MANDATORY SERVICE BULLETIN**NUMBER:** SB13-08**REVISION:** 00**DATE:** November 18, 2013**SUBJECT:** VISOR BRACKET**EFFECTIVITY:**

KODIAK® 100 Series Aircraft Serial Numbers: 100-0001 through 100-0085

Visor Bracket Retrofit

FSI-052

Figure 3-1: Visor Bracket Overview

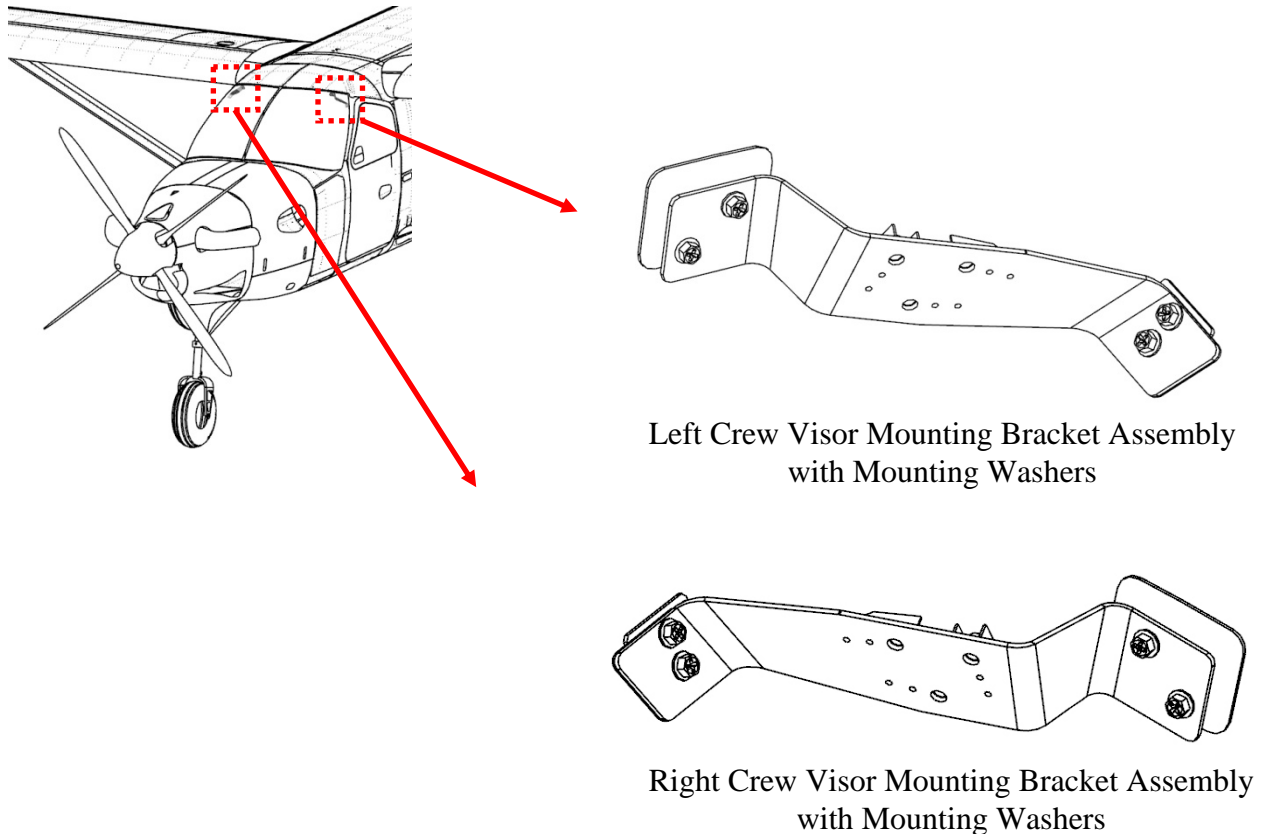
This Field Service Instruction provides guidance for relocating the pilot and copilot visor assemblies.

Figure 5-1: Visor Bracket Location

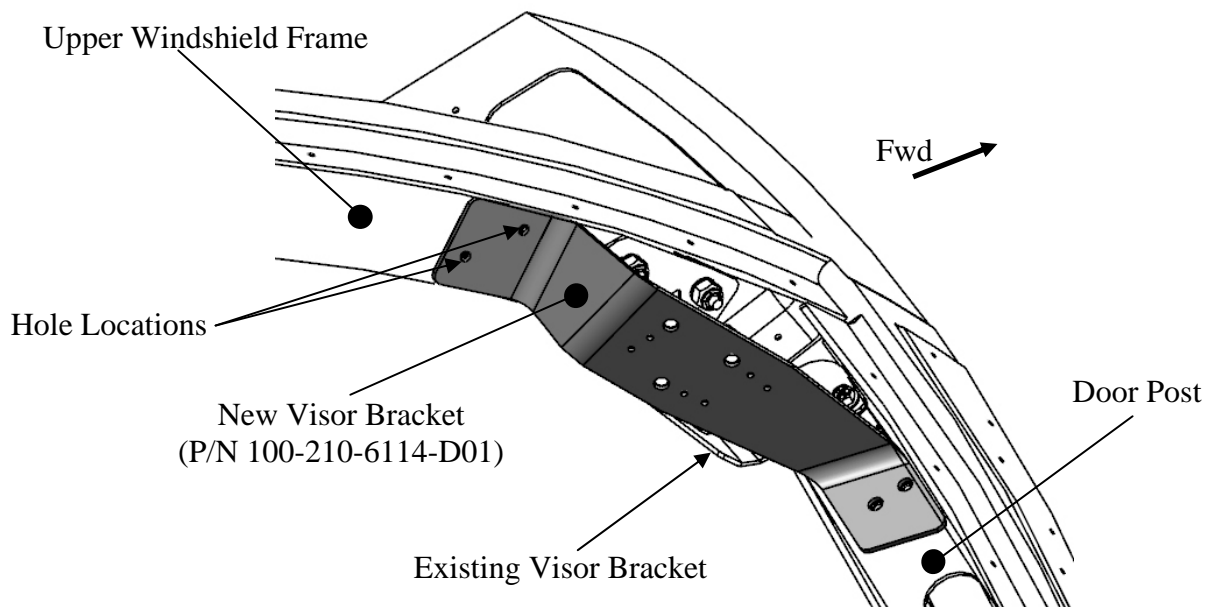
1. Using **Figure 5-1** as a guide, hold the new left visor bracket (P/N 100-210-6114-D01) in its approximate location and mark where the holes will be located on the upper frame.

Figure 5-2: Visor Hardware Assembly

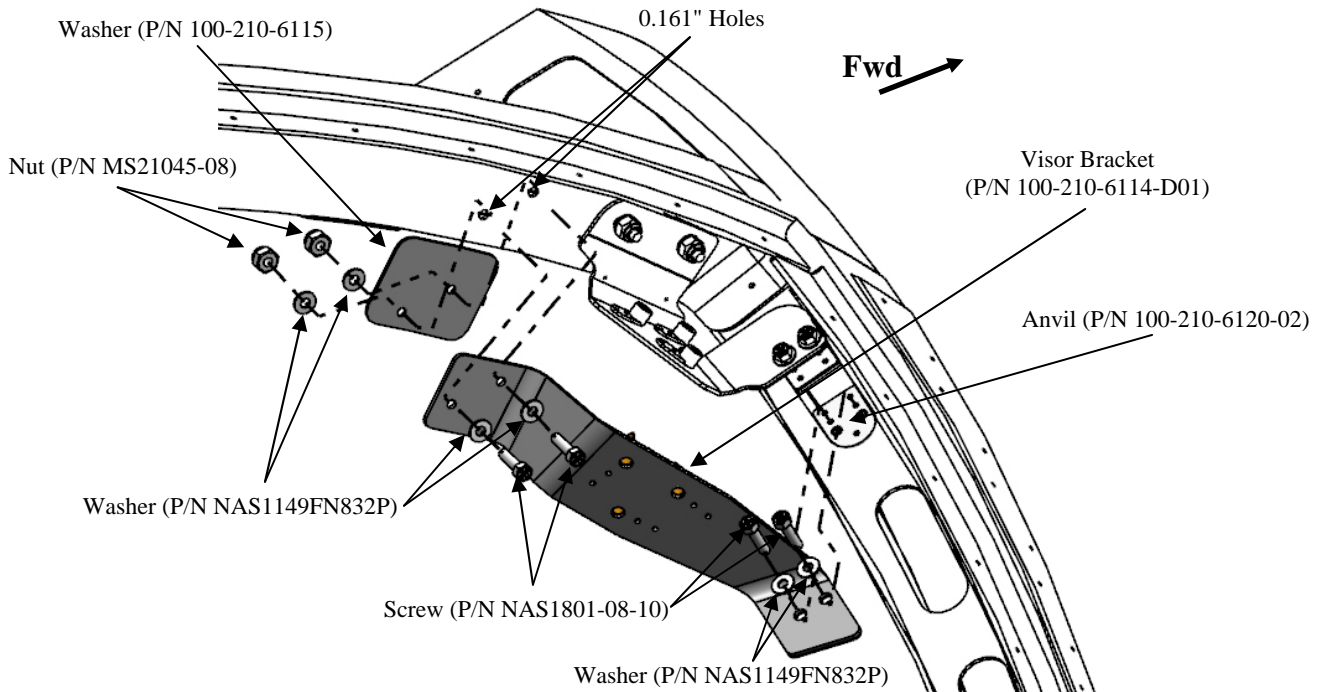
- Using **Figure 5-2** as a guide, pre-assemble the washers (P/N NAS1149FN832P), screws (P/N NAS1801-08-10), and anvil assembly (P/N 100-210-6120-02) onto the new visor bracket (P/N 100-210-6114-D01). Allow the anvil assembly (P/N 100-210-6120-02) to be very loose on the screws (P/N NAS1801-08-10).

6. Drill two (2) holes in the upper windshield frame (0.161" to 0.167"), and deburr as necessary.
7. Install the washer (P/N 100-210-6115), four (4) screws (P/N NAS1801-08-10), six (6) washers (P/N NAS1149FN832P), and two (2) nuts (P/N MS21045-08). Refer to **Figure 5-2**.
8. Torque the nuts (P/N MS21045-08) and the screws (P/N NAS1801-08-10) to 12-15 in-lb.

Figure 5-3: Bracket Edge Distance

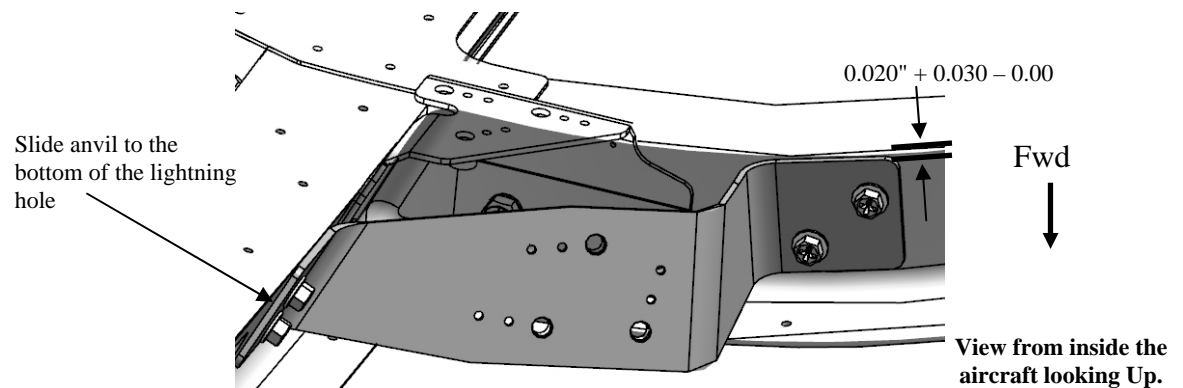
- Slide the anvil assembly (P/N 100-210-6120-02) into place in the side frame lightening hole.
- Ensure a minimum edge distance of $0.020'' +0.030 - 0.00$ is maintained between the bottom edge of the upper windshield frame and the bottom edge of the visor bracket. Refer to **Figure 5-3** for further details.
- Using **Figures 5-1** and **5-3**, position the visor bracket (P/N 100-210-6114-D01) and mark the center of the holes in the bracket onto the upper windshield frame.

Figure 5-5: Locating Nutplate Holes

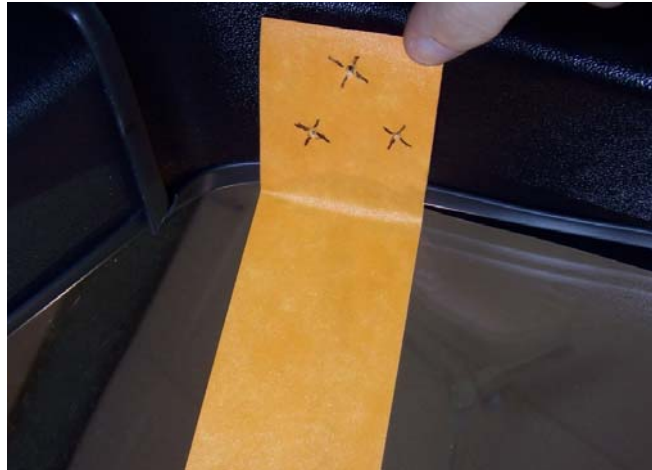
1. Using a piece of 2" masking tape, make a hole locator and tape to windshield. Lay the locator over the new visor bracket and mark the center of the three nutplates. See **Figure 5-4**.
2. Fold both hole locators out of the way and reinstall the forward cockpit headliner panel in accordance with the *KODIAK® 100 Airplane Maintenance Manual*, Chapter 25.
3. Lay the hole locators over the headliner and use a sharp scribe or punch to transfer the holes through the left and right locators into the headliner. See **Figure 5-5**.

4. Drill #40 holes in the locations marked (left and right side). Carefully enlarge the holes to 0.194", adjusting to match the nutplates. The holes may need to be slightly oversized to match the nutplates.
5. Install and position both visor assemblies in their new locations. Refer **Figure 5-6**.
